UPPER UWCHLAN TOWNSHIP
PLANNING COMMISSION
AGENDA

JULY 11, 2024

Upper Uwchlan Township Village Concept Plan Update 2024

SHEET NUMBER:
A200
8 OF 16

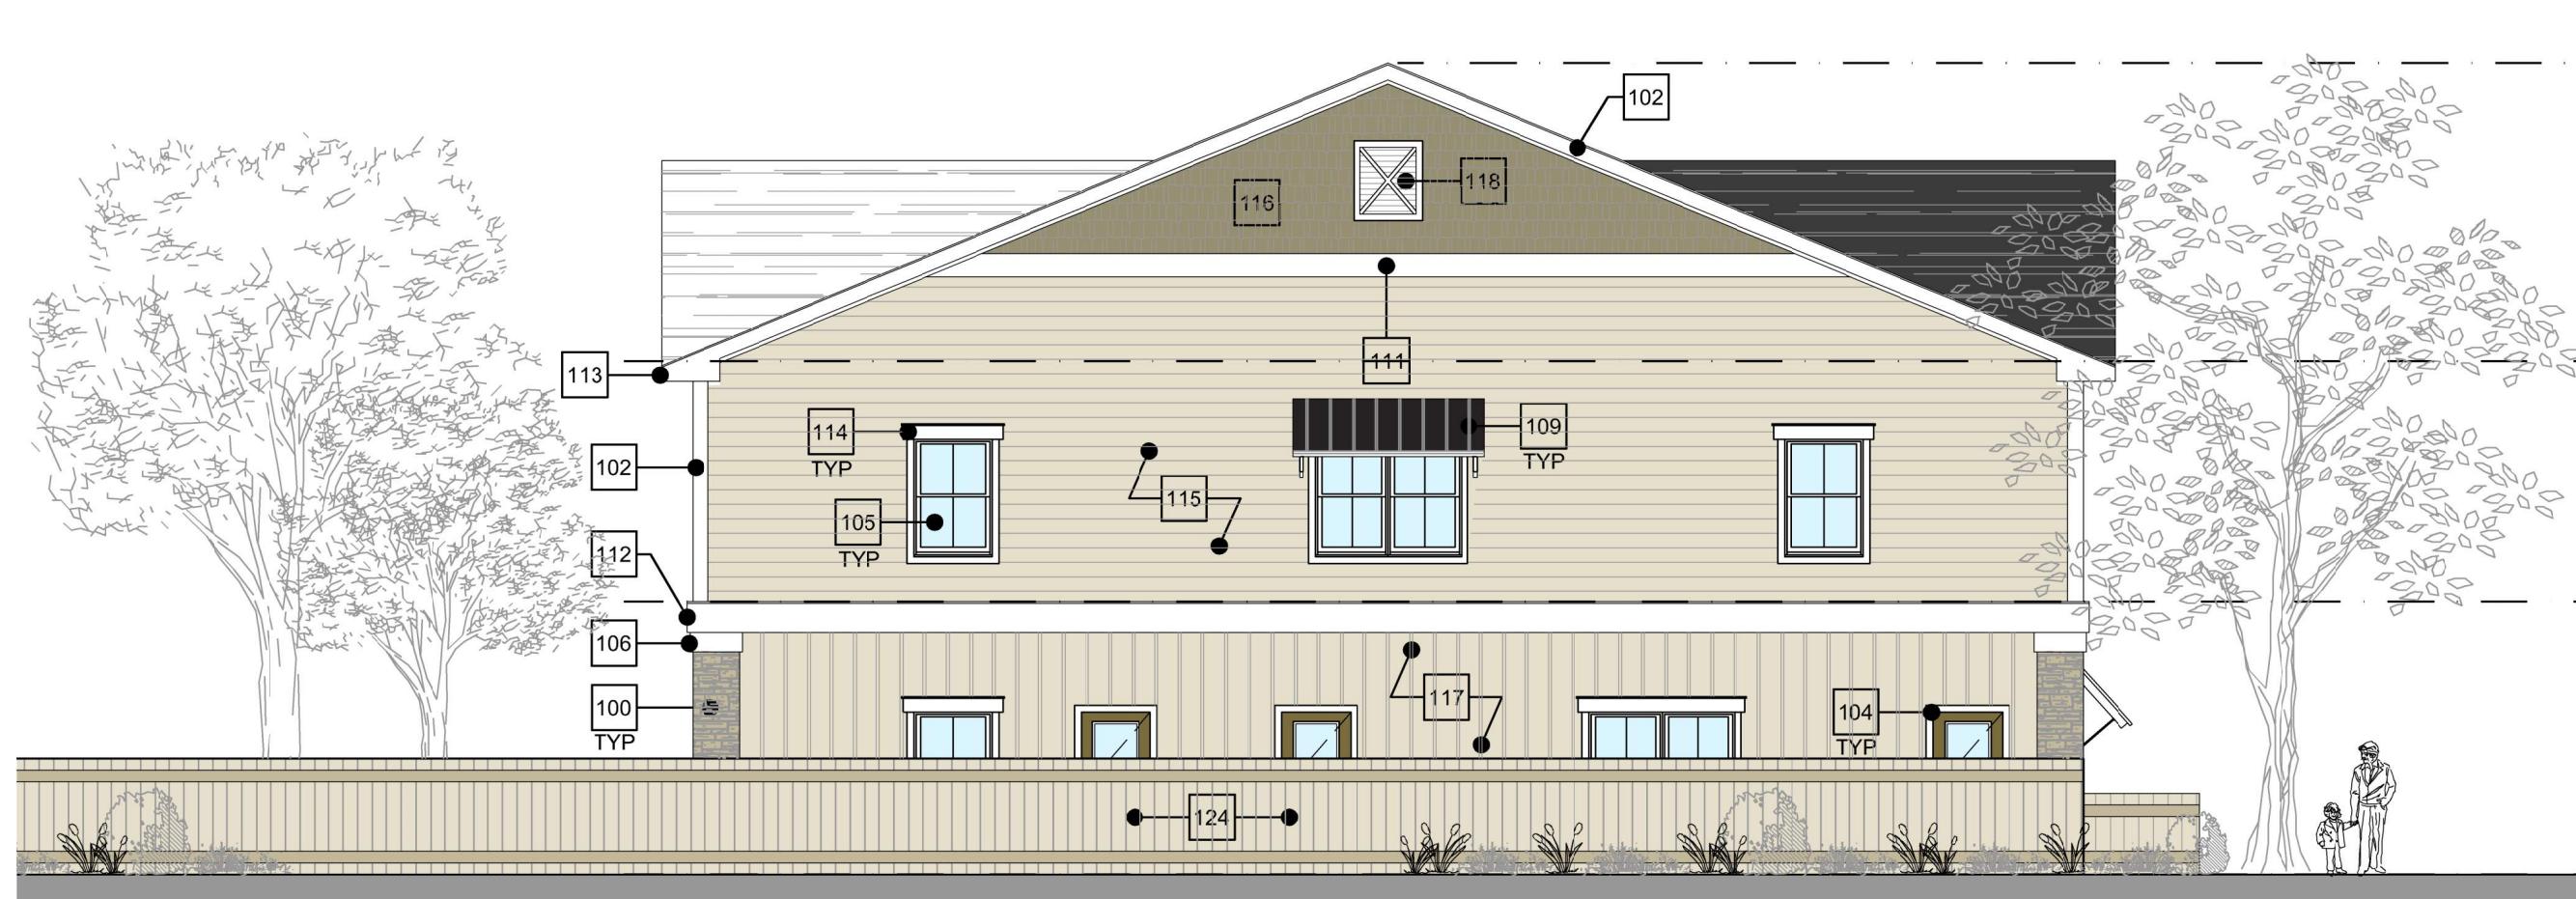
70. Mr. Kelly introduced revised architectural plans dated May 12, 2024 for the proposed day-care building as Exhibit A-7. The revised architectural plans depict fences around the playground areas and the HVAC system on the western side of the building.
